E/ECE/324
E/ECE/TRANS/505 } Rev.1/Add.25/Amend.2

Addendum 25: Regulation No. 26

Amendment 2

UNIFORM PROVISIONS CONCERNING THE APPROVAL OF VEHICLES WITH REGARD TO THEIR EXTERNAL PROJECTIONS

Model A

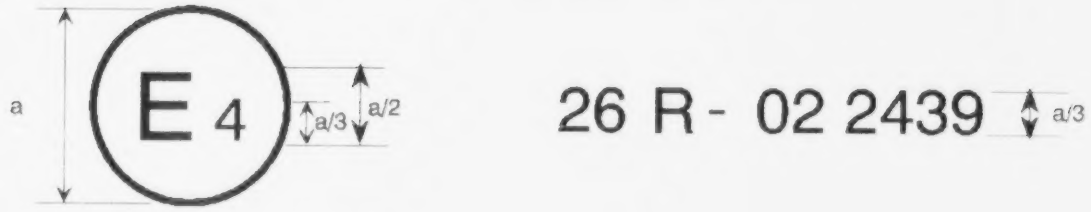
Annex 2, replace by the following:

The above approval mark affixed to a vehicle shows that the vehicle type concerned has been approved in the Netherlands (E4) pursuant to Regulation No. 26 and under approval number 022439. The first two digits of the approval number indicate that, at the time of approval, Regulation No. 26 included the 02 series of amendments.

Figure 3

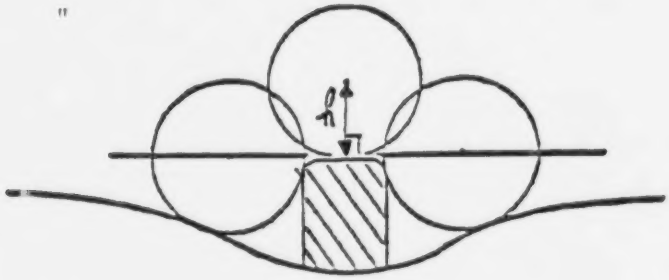
2.2. If the dimension of the projection of a component which is mounted on a surface other than convex cannot be determined by simple measurement, it shall be determined by the maximum variation of the distance of the centre of a 100 mm diameter sphere from the nominal line of the panel when the sphere is moved over and is in constant contact with that component. Figure 3 shows an example of the use of this procedure.

Figure 4

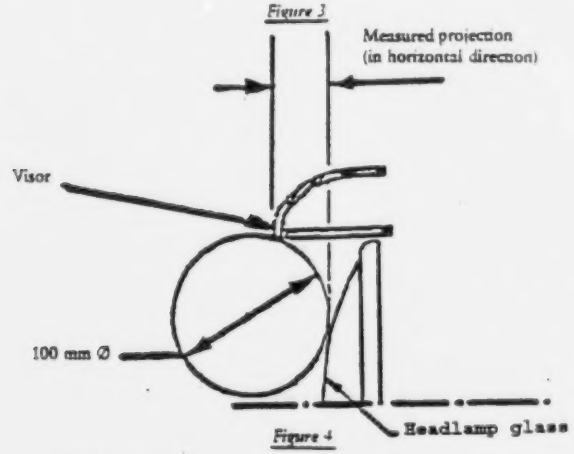
3.1. The projection from the external surface of the headlamp shall be measured horizontally from the point of contact of a 100 mm diameter sphere as shown in Figure 4.

Figure 5

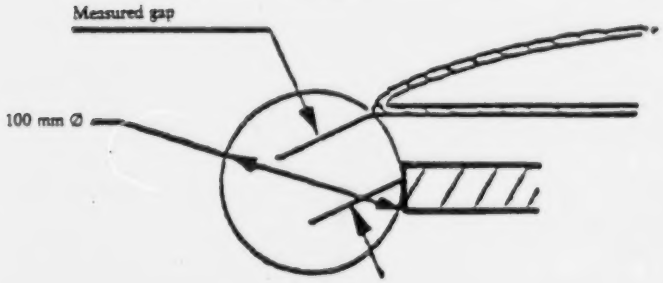
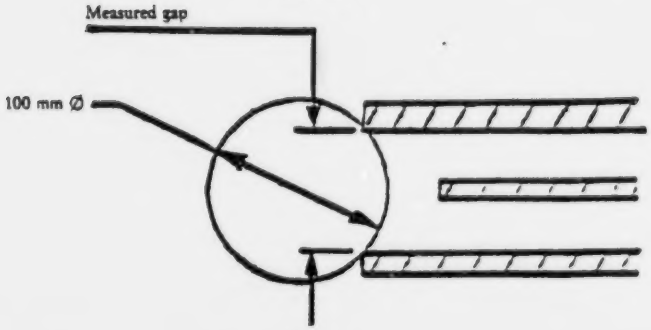
4.1. The dimension of a gap or space between elements of a grille shall be determined by the distance between two planes passing through the points of contact of the sphere and perpendicular to the line joining those points of contact. Figures 5 and 6 show examples of the use of this procedure."
